DELANEY PARK HEALTH & REHABILITATION (REPLAT)

SUMMARY

| <p><i>Updated: April 28, 2013</i></p> | <p>Staff Recommendation: Approval of the Minor Plat, subject to conditions in this staff report.</p> | |

PROPOSED PLAT

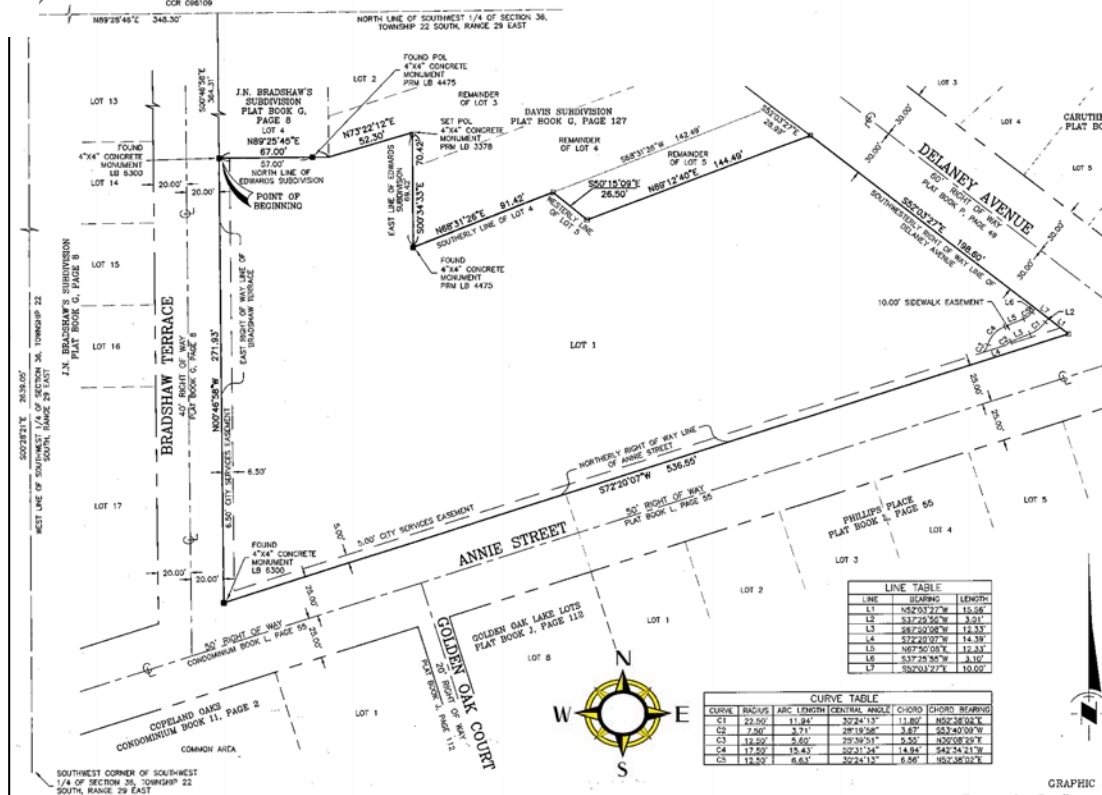
Plat Face Changes - In addition to any changes required on the plat, the following is a list of additional requirements:

- a) Changes to the face of the plat. (A copy has already been returned to the surveyor).
- b) Recording Fees (Checks should be made payable Orange County Comptroller.)
- c) The plat must be reviewed by Orange County prior to recording. Begin this process by taking a copy of the executed plat to Room 1700 (Orange County Property Appraiser's Office, Attn. Rocco Campanale), 200 S. Orange Avenue, Sun Trust Bank Center. The original completed Statement of Lien from Orange County is required by this office. The Statement of Lien must be received by this office prior to recording the plat.
